Response to Comments: #2

Response to Comments: #3

Response to Comments: #4

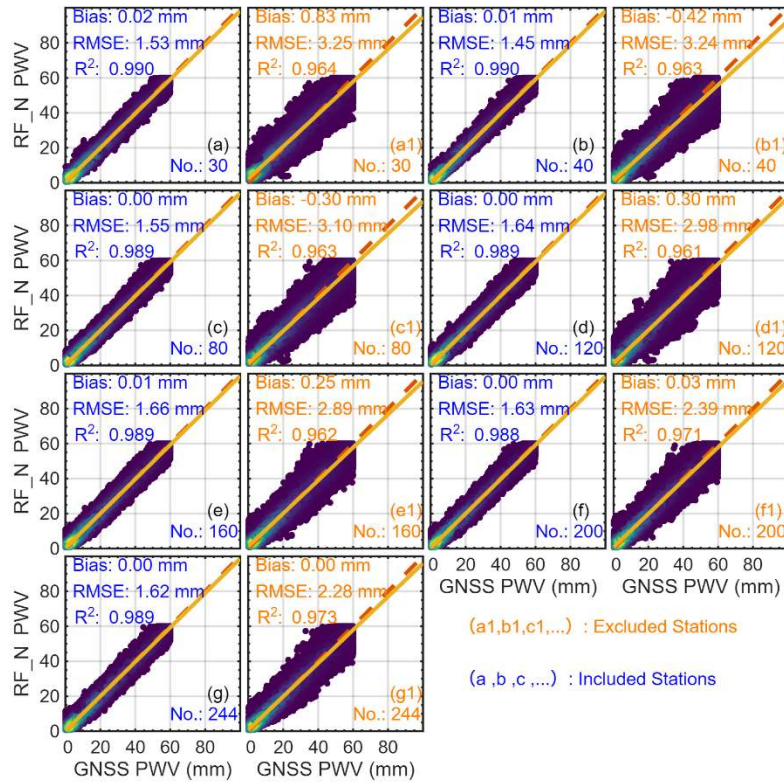
2. The meaning of the subplot labels (a/a1, b/b1) in Figures 3 and 4 needs to be explained more clearly in the main text. Furthermore, the color bar ranges and unit labels in Figures 5–7 suffer from overlap and occlusion; layout adjustments are recommended.

Reply: Figures 3-7 have been revised, including adjustments to the meaning represented by each subplot and the color bar.

Figure 4: Validation Results of different Models Using GNSS Stations Not Involved in Model Training

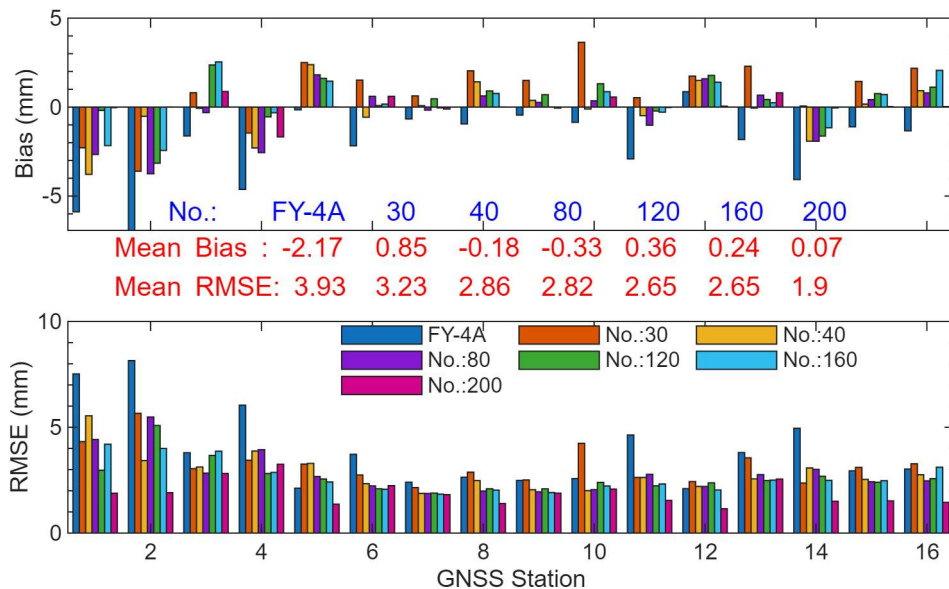
11. Lines 231–235 (Figure 4): The FY-4A original product has a Bias of -2.17 mm and an RMSE of 3.93 mm. Please clarify the baseline for these metrics—specifically, which time period and what matching conditions they are based on—and state this in the main text.

Reply: Figure 4 illustrates the inversion performance of each model validated using data from 16 stations (not involved in training) for the year 2023. Additional explanations have been provided as suggested by the reviewer.

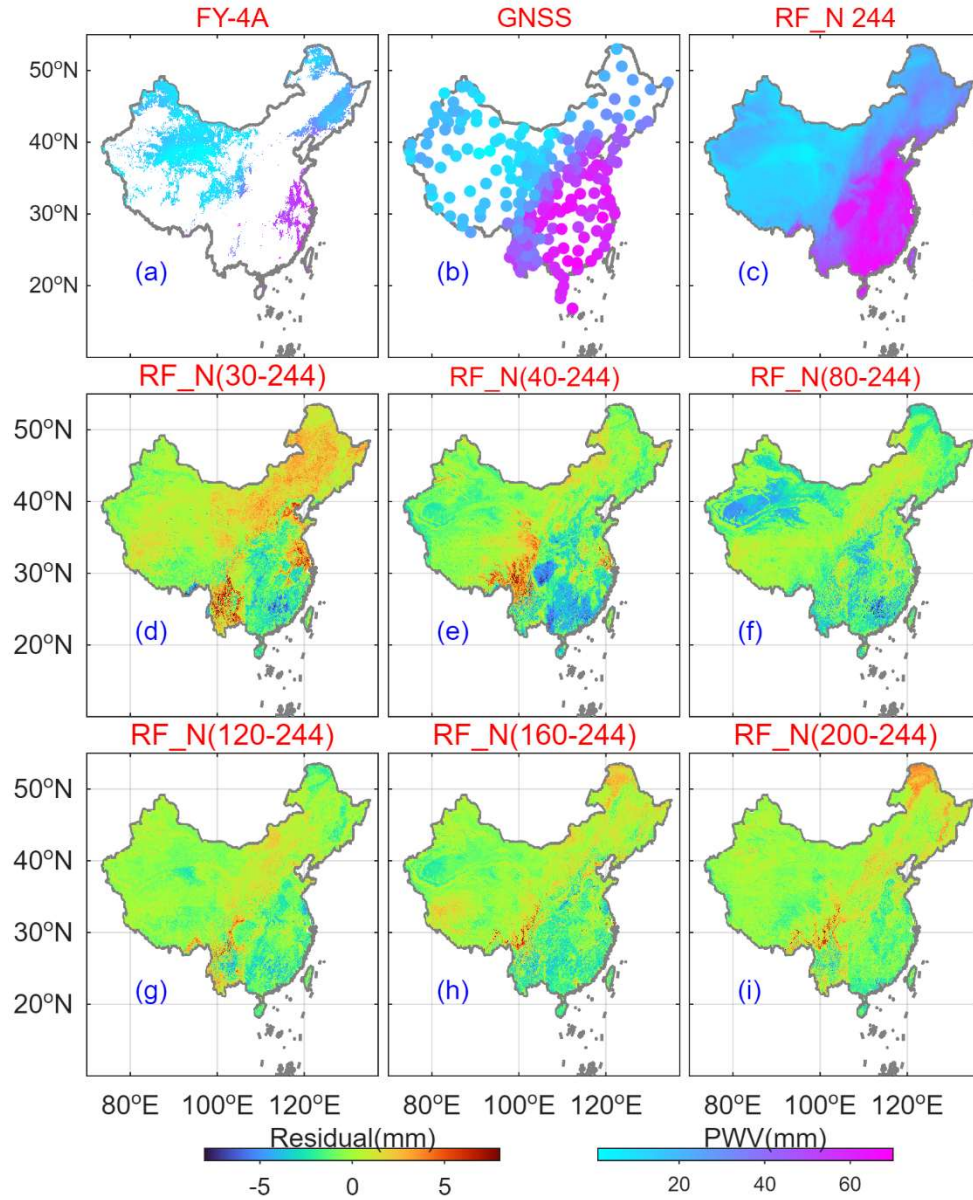
(1) Some figures contain a large amount of information, especially multi-panel result figures. It is suggested that the authors further standardize the size and layout of the figures. For example, the aspect ratios of the subplots in Figures 6 and 7 could be appropriately adjusted to improve the standardization and consistency of the manuscript.

15. Figure 6: The color bar label "ERRO(mm)" should be changed to "Error (mm)"; the "PWV(mm)" and "ERRO" color bars overlap and occlude each other; separate layout is suggested.

Reply: The images have been adjusted according to the reviewers' suggestions.

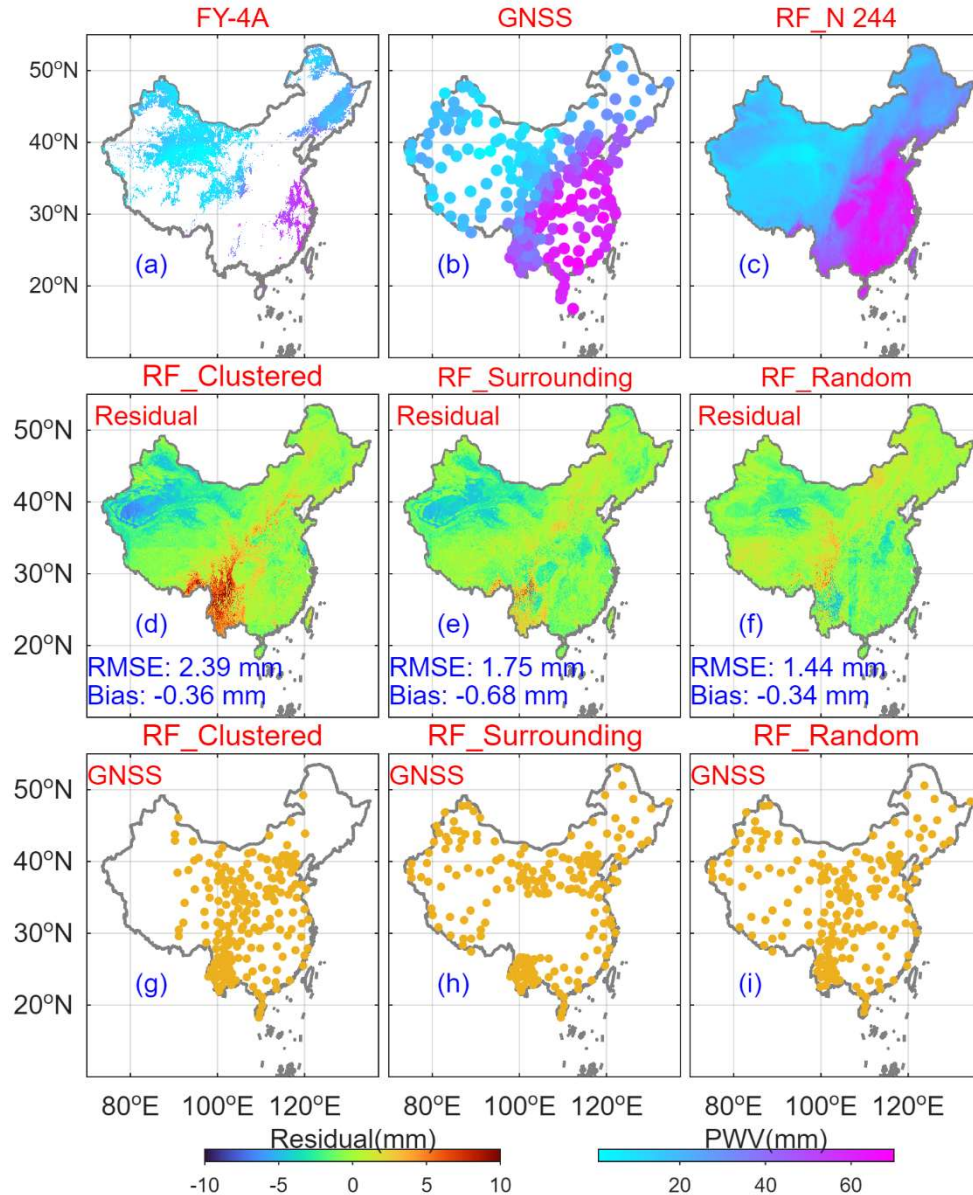
16. Figure 7: The three-row, three-column structure is good, but the naming "RF_Area_1/2/3" is suggested to be changed to "RF_Clustered / RF_Surrounding / RF_Random" for better readability.

Reply: Based on the reviewer's suggestion, I have changed the terms from "RF_Area_1/2/3" to "RF_Clustered / RF_Surrounding / RF_Random" accordingly.

Figure 1: Spatial Distribution of GNSS and IGRA Stations in China.

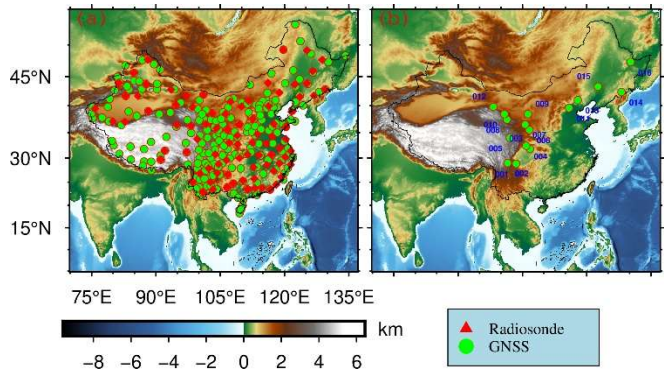
5. Figure 4 uses bar charts to display Bias and RMSE for 16 independent validation stations and 6 models, resulting in extremely high information density. Moreover, the negative bias bars of the raw FY-4A data obscure the details of the calibrated models. Suggestions: (i) Plot the raw FY-4A results separately or use a logarithmic scale; (ii) Add a cross-reference between station numbers and geographic locations (can be annotated in Fig. 1b); (iii) Supplement the standard deviation across the 16 stations for each model to characterize spatial consistency.

Reply: The adjustments to Figure 4 have been completed, and station numbers have been added to the measurement locations in Figure 1b.

Figure 5. Spatial distribution of validation accuracy for different models using IGRA stations.

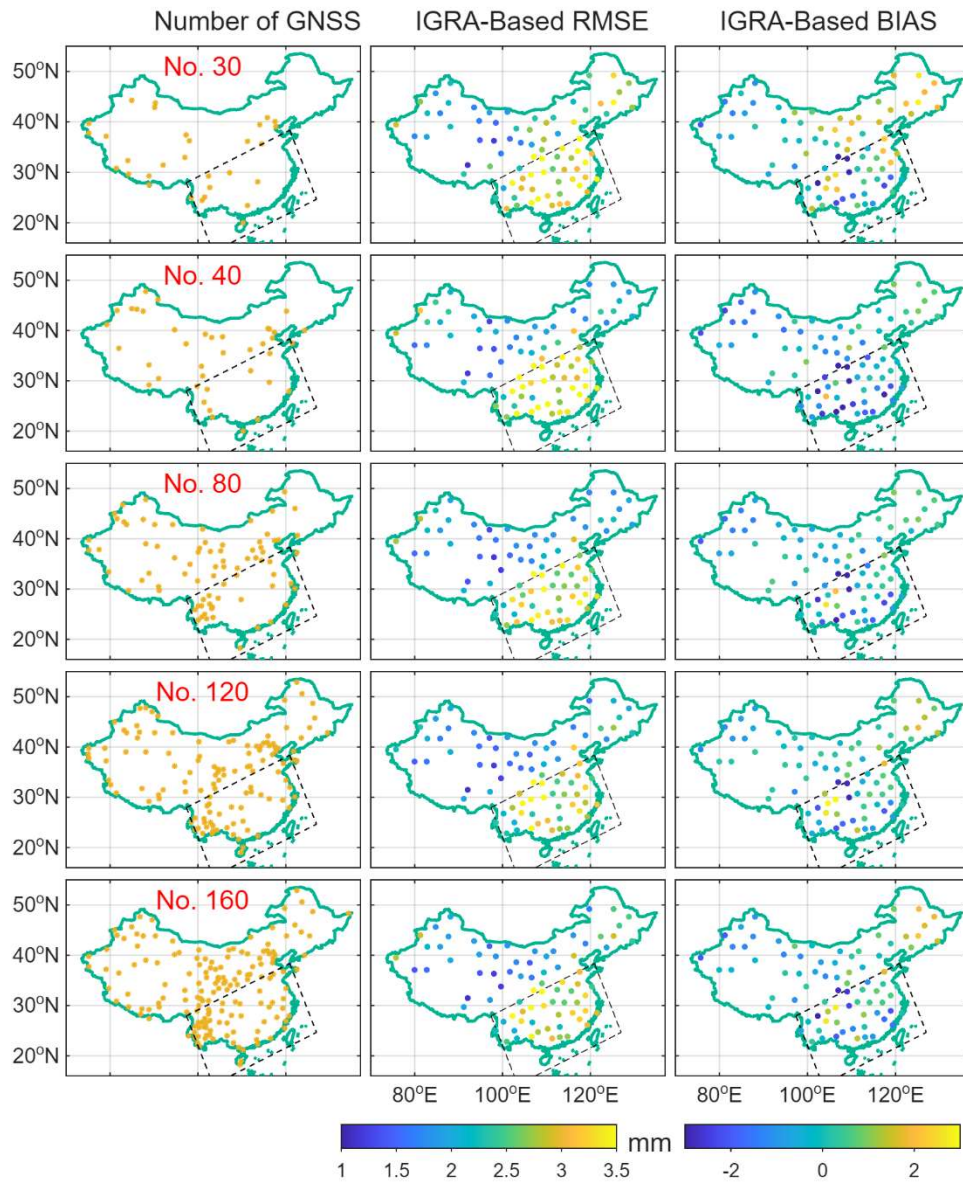
10. The titles of Figures 5, 6, and 7 are too brief and lack key information. It is recommended to clearly state in each title what each subfigure (a, b, c, etc.) corresponds to, so that the figures can be understood independently.

Reply: Revisions have been made to the titles of Figures 5-7, with clarifications added regarding the content corresponding to each subfigure.
